D4002-041 DRAIN HOSE - FRONT

D4002-043 DRAIN HOSE - REAR

PRELIMINARY ISSUE

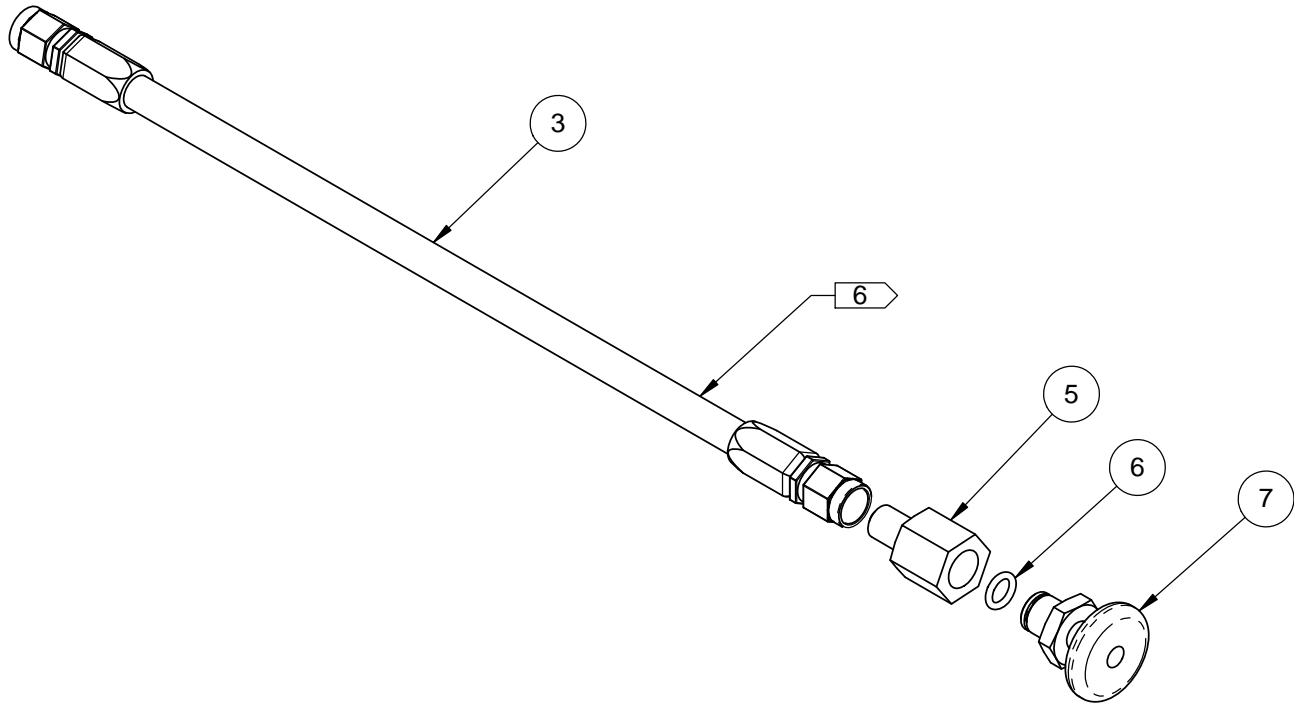
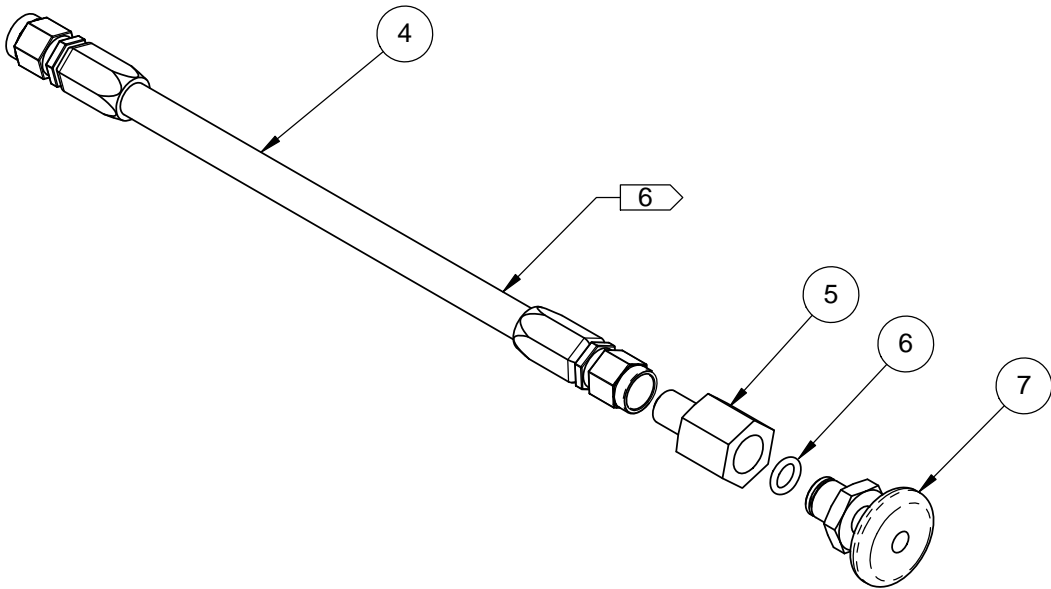
PC1	ADDED 8.00" TO D4002-1/-3 HOSES; AFFECTED WEIGHT	MB	11.09.19
B	CHANGE LENGTH MEASUREMENT FOR -3, ZN C2-2	HS	10.11.03
A	NEW ISSUE	HS	10.03.01
REV.	DESCRIPTION	BY	DATE
DESIGN		DART AEROSPACE LTD HAWKESBURY, ONTARIO, CANADA	
DRAWN			
CHECKED		DRAWING NO.	REV. PC1
MFG. APPR.		D4002	SHEET 1 OF 2
APPROVED		TITLE	SCALE
DE APPR.		HOSE ASSEMBLY	NTS
DATE	11.09.19	COPYRIGHT © 2010 BY DART AEROSPACE LTD THIS DOCUMENT IS PRIVATE AND CONFIDENTIAL AND IS SUPPLIED ON THE EXPRESS CONDITION THAT IT IS NOT TO BE USED FOR ANY PURPOSE OR COPIED OR COMMUNICATED TO ANY OTHER PERSON WITHOUT WRITTEN PERMISSION FROM DART AEROSPACE LTD.
